September 14, 2016

Subject: Review of Draft EIR for General Waste Discharge Requirements for Vineyard Dischargers in the Napa River and Sonoma Creek Watersheds.

Subject: Landslide Hazard Assessment
 Walt Ranch Erosion Control Plan (P11-00205-ECPA)
 Walt Ranch Project, Napa, CA

FIGURE 1: Hydrologic model configuration for existing conditions (no drainage improvements) drainage outfall from Vineyard Block 21B.

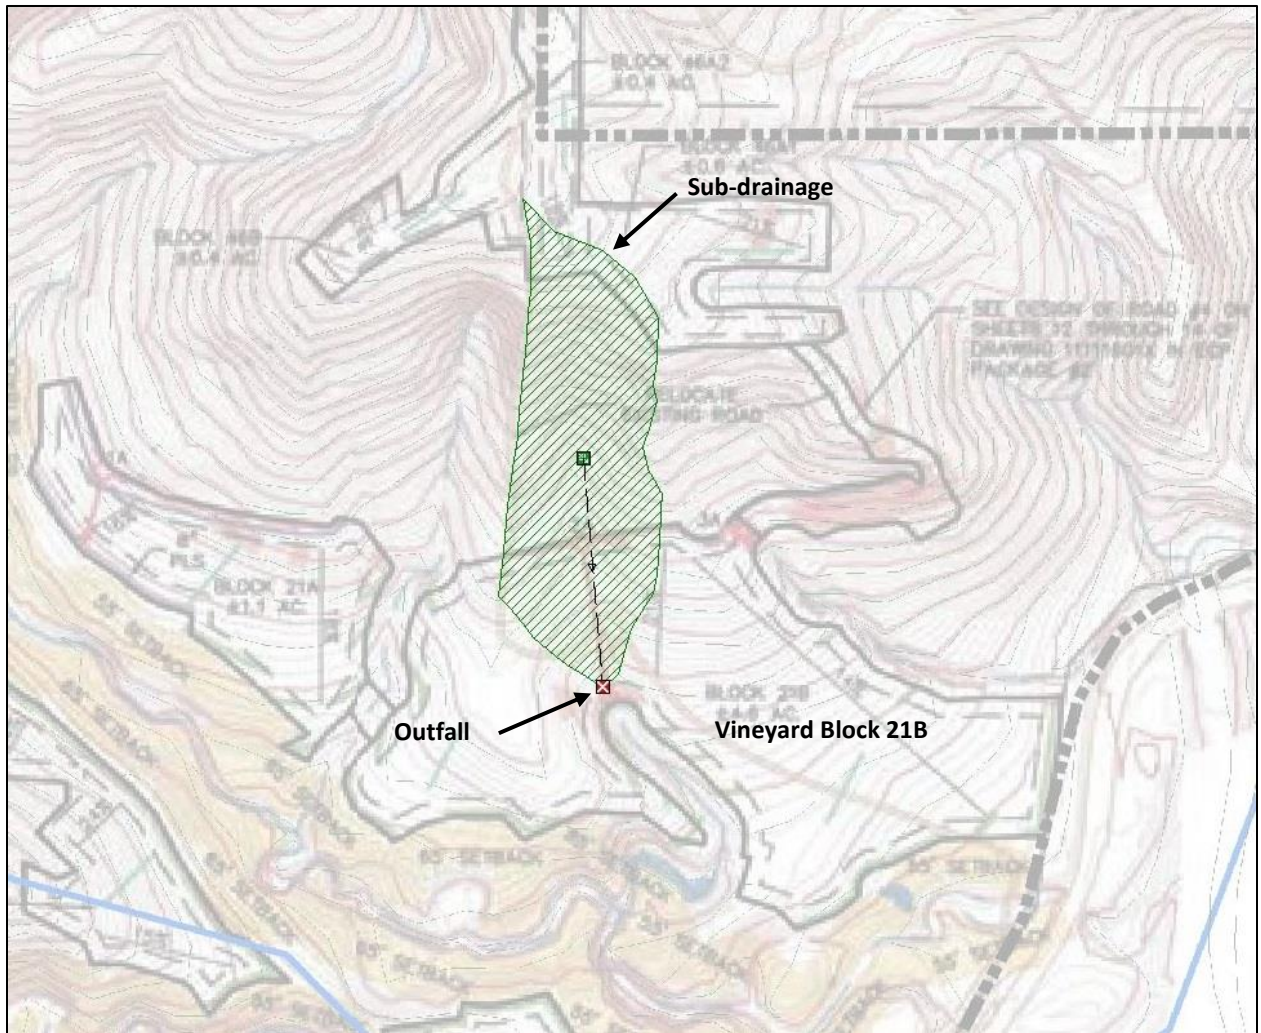
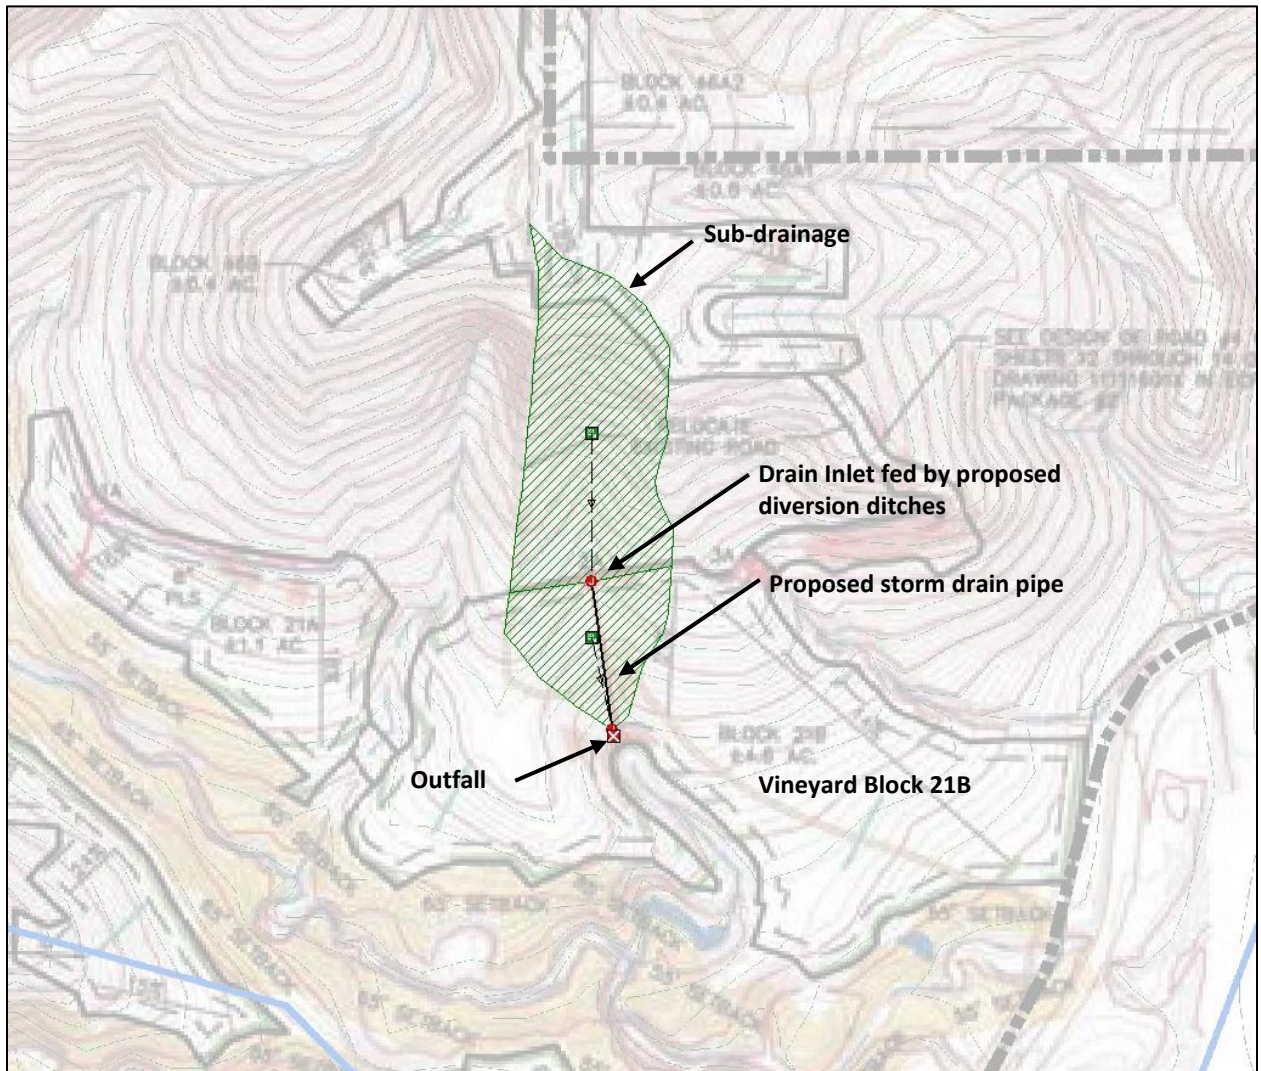
To better understand and quantify the different effect runoff curve number and drainage elements have on storm runoff, we completed a hydrologic modeling analysis on a proposed drainage outfall in Vineyard Block 21B. We chose this site because the EIR concludes that the drainage area to this outfall does not change between pre- and post-project conditions [cite to page number] and the vineyard block includes drainage elements including internal diversion ditches that feed into a surface drainage pipeline [cite to page number]. Figure 1 presents the 2.17-acre drainage area contributing to the outfall. Approximately two-thirds of the drainage area lies north of the proposed vineyard block while the lower third of the drainage area lies within the vineyard.

Our hydrologic analysis follows the same modeling approach and methods, rainfall intensities, NRCS TR-55 travel time computation and other model assumptions as those used by RiverSmith in their hydrologic analysis. However, in lieu of using the same USACE HEC-HMS computer program, we used the StormCAD module integrated with our AutoCAD computer design program. The StormCAD program contains the same time of concentration and rainfall runoff equations/methods used in the RiverSmith hydraulic analysis. Using these tools, we developed three model scenarios as part of our analysis: 1) existing conditions (pre-project); 2) post-project without any drainage elements; and 3) post-project including the proposed drainage elements. Figure 2 depicts the model configuration of the third model scenario. Consistent with the curve numbers presented by RiverSmith in Appendix F of the DEIR, we assume a pre-project curve number of 78.2 for the entire water shed area, including vineyard. Under post-project conditions, we assume the curve number within the vineyard area is lowered to 75 while curve number for the rest of the watershed remains at 78.2. Thus, the composite curve number decreases under the post-project model scenarios. We simulated three of the RiverSmith 24-hour precipitation events for each model scenario including the 2-, 10- and 100-year storm events. The simulated peak storm runoff rates from this analysis are presented in Table 1.

As predicted by RiverSmith, simulated project runoff rates with no drainage improvements (column B, Table 1) are slightly lower than pre-project condition peak flow rates (column A, Table 1) due to a reduction in the composite runoff curve number. These changes equate to a 3%, 2.5% and 1% reduction in the 2-, 10- and 100-year peak storm flow rates, respectively. However, integrating the vineyard drainage elements into the runoff model results in peak flow rates that are notably higher (column C, Table 1) than those under pre-project conditions. Increases in post-project flow rates from the Block 21B outfall that also consider the internal drainage elements are 12.4%, 13.5% and 15.7% higher than pre-project 2-, 10- and 100-year peak storm flow rates, respectively. This means that the flow reductions realized with a reduction in runoff curve number are negated and reversed by the effects of the internal drainage ditches and pipelines designed to collect, concentrate and accelerate flow off the vineyard block.

The results of our hydraulic analysis of Block 21B highlight the deficiencies of the EIR in accurately identifying areas of increased runoff and erosion potential. This example illustrates that a determination on the changes in runoff from vineyard blocks based solely on a qualitative

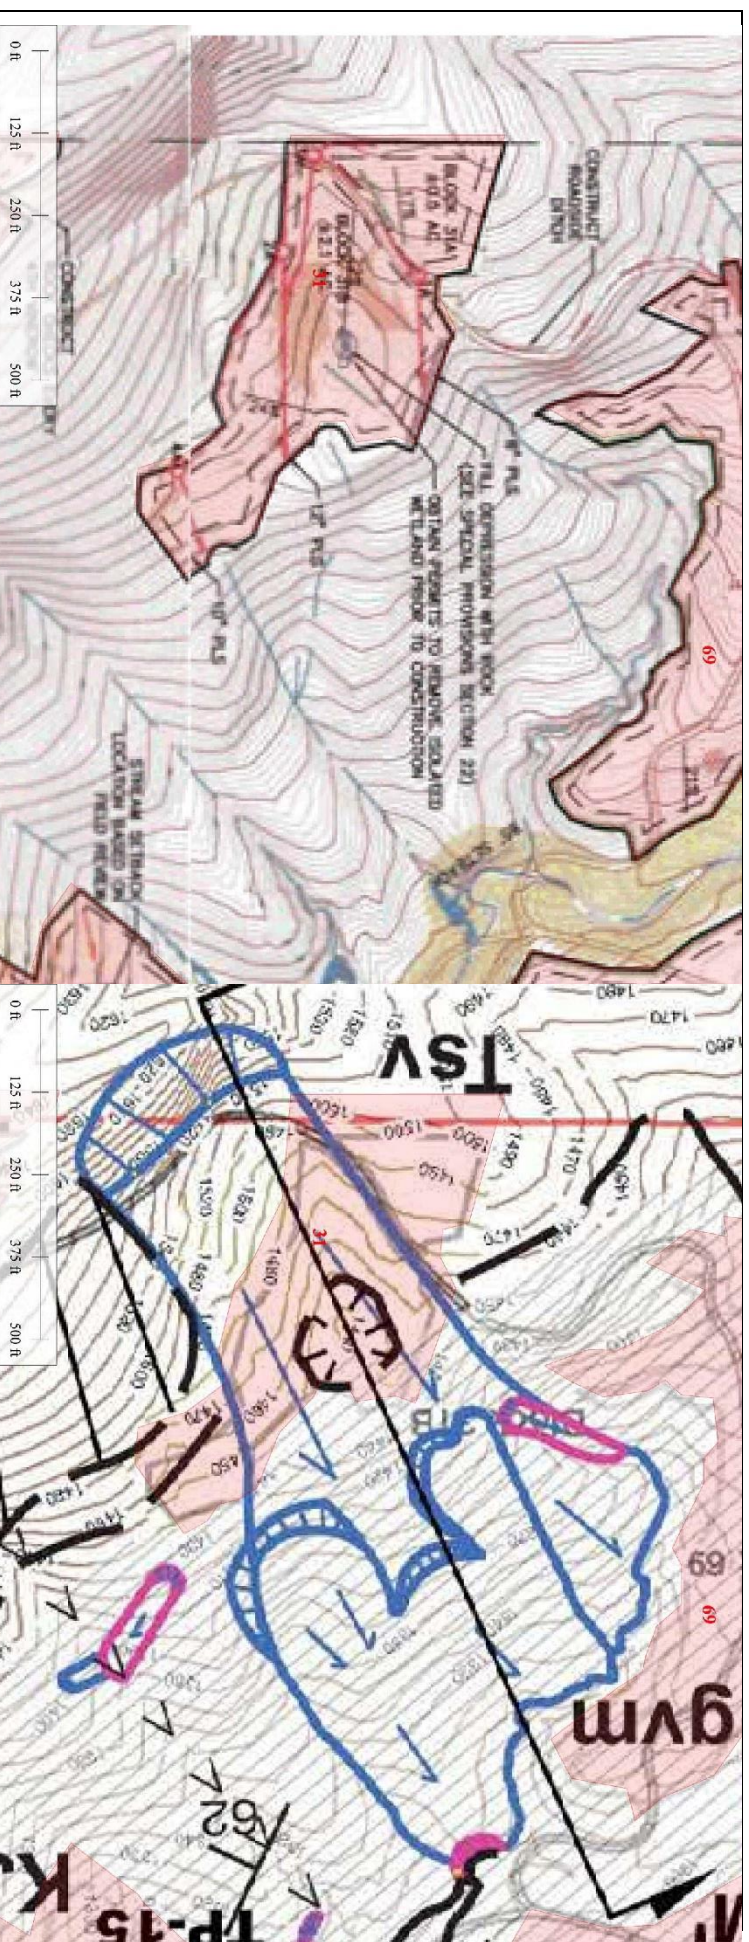
Contrary to the statements by Gilpin, we have identified a number of vineyard blocks that discharge runoff from vineyard blocks directly onto mapped landslides. We identified these vineyards by georeferencing and overlaying project erosion control plans and the site geologic map. We evaluated a subset of the 69 vineyard blocks, focusing only on the 41 blocks where post-project storm runoff rates exceed pre-project rates as estimated by RiverSmith (2013). Of these blocks, we found that drainage from blocks 31A, 40B, 50, 52, 54, 57 and 61 will be directed directly onto mapped landslides. A comparison of erosion control plans⁴ and landslide conditions at each of these vineyard blocks are presented in Figures 5 through 10. In order to mitigate for the increased flow rates from these blocks (i.e., reduce them to pre-project levels), the following mitigation measures are proposed: installation of small detention structure or gravel berm on downslope edge of the turnaround avenue at Blocks 31A and 40B; installation of localized detention structure of appropriate size at Blocks 50 and 52; and installation of a gravel berm on the downslope edge of the turnaround avenue at Blocks 54, 57, and 61. All of these proposed berm and detention structures will be located on mapped landslides (Figures 5-10). This will result in water being ponded and possible dispersed more widely on landslide deposits if a structure is overtopped. These mitigations will promote and concentrate infiltration into landslide deposits to a greater degree than would occur under pre-project conditions. Thus, proposed project mitigations are increasing the potential to reactive landslides in these seven specific areas. Although the remaining 34 berm and/or detention sites are not located on active or dormant landslides, they occur in geology and soils prone to sliding and also introduce an

FIGURE 1: County designated MST groundwater basin (Source: Napa County Groundwater Ordinance).

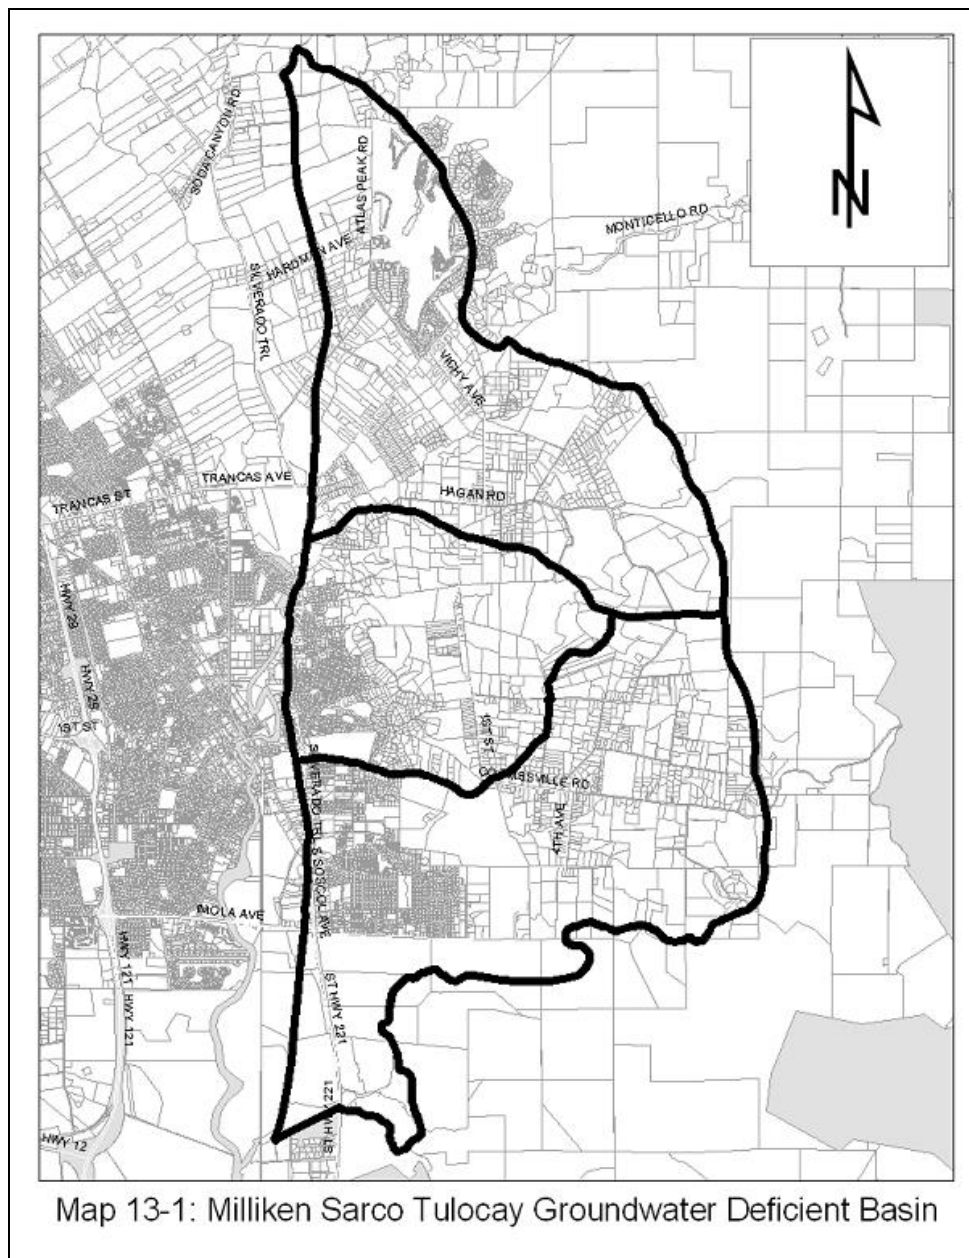
The County appears to delineate the MST basin as indicated in Figure 1 (Napa County Ordinance No. 1294, Chapter 13.15 Groundwater Conservation). The County’s MST delineation likely comes from the “Study Area” designation presented in the 1977 USGS report (Johnson, 1977) cited in the WAA. The “Study Area” outlined in 1977 USGS report defines the downstream alluvial aquifer and underlying Sonoma Volcanic groundwater storage areas associated with known groundwater overdraft. This “Study Area” encompasses a 15-square mile area within the cumulative 42-square mile drainage area for the Milliken, Sarco and Tulucay Creek watersheds (see Figure 2). However, here is where policy and science diverge with respect to defining a groundwater basin.
